HOLDOVER

BAYVIEW HEIGHTS SUBDIVISION, **PIERCE ADDITION TO**

APPLICATION NUMBER Holdover DATE January 5, 2006
APPLICANT Bayview Heights Subdivision, Pierce Addition To
REQUEST Subdivision

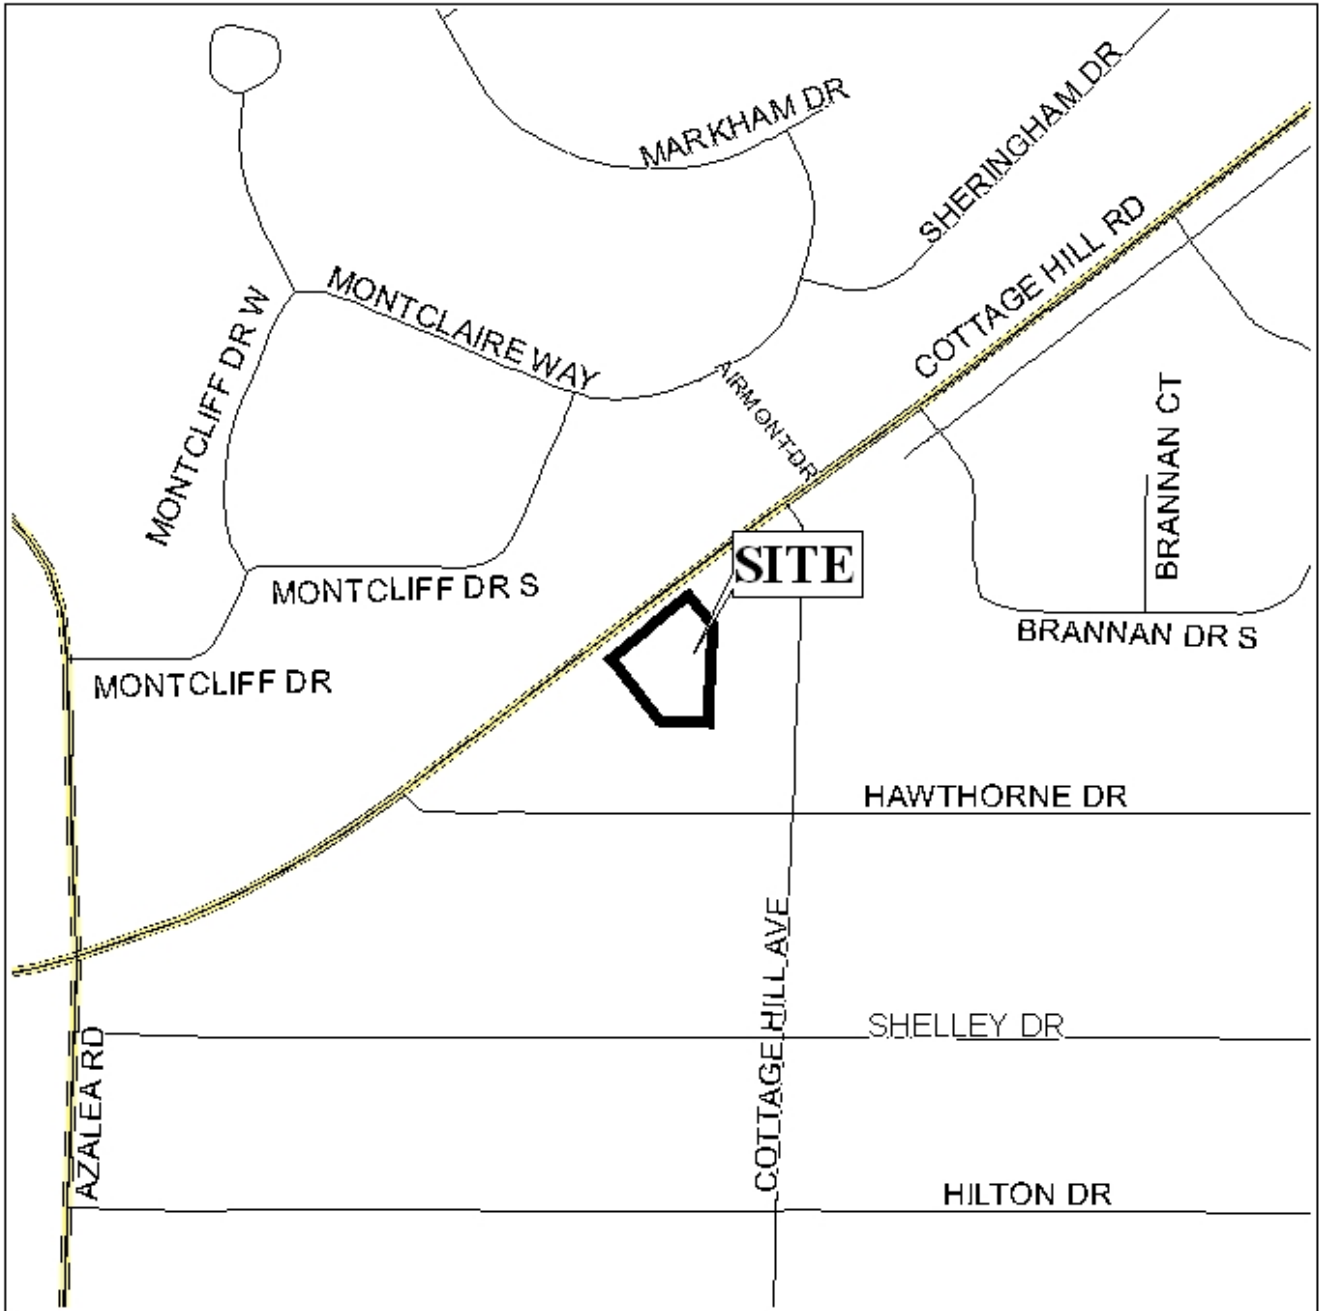
The plat illustrates the proposed 0.8± acre, 2-lot subdivision located on the South side of Cottage Hill Road, 260'± West of Cottage Hill Avenue, which is in Council District 4. The site is served by public water and sanitary sewer.

The site fronts Cottage Hill Road, which has an 80-foot right-of-way, and requires a 100-foot right-of-way as depicted on the Major Street Plan; thus sufficient dedication to provide 50 feet from the centerline of Cottage Hill Road should be required. Furthermore, the 25-foot building setbacks should be measured from the dedication and shown thus on the final plat.

The legal description of the site indicates that the entire parent parcel is not included in the application, and that a triangular portion of the original Lot 11 (Bayview Heights) was conveyed to the owners of Lots 16 and 17 (Bayview Heights) in 1969, after the introduction of the Subdivision Regulations. Furthermore, while this property is excluded from the legal description of the subject property, it is not included in the legal description of the parcel including Lots 16 and 17.

The plat meets the minimum requirements of the Subdivision Regulations and is recommended for Tentative Approval, subject to the following conditions: 1) dedication of sufficient right-of-way to provide 50 feet from the centerline of Cottage Hill Road; and 2) the depiction of the 25-foot setback lines, as measured from the dedication.
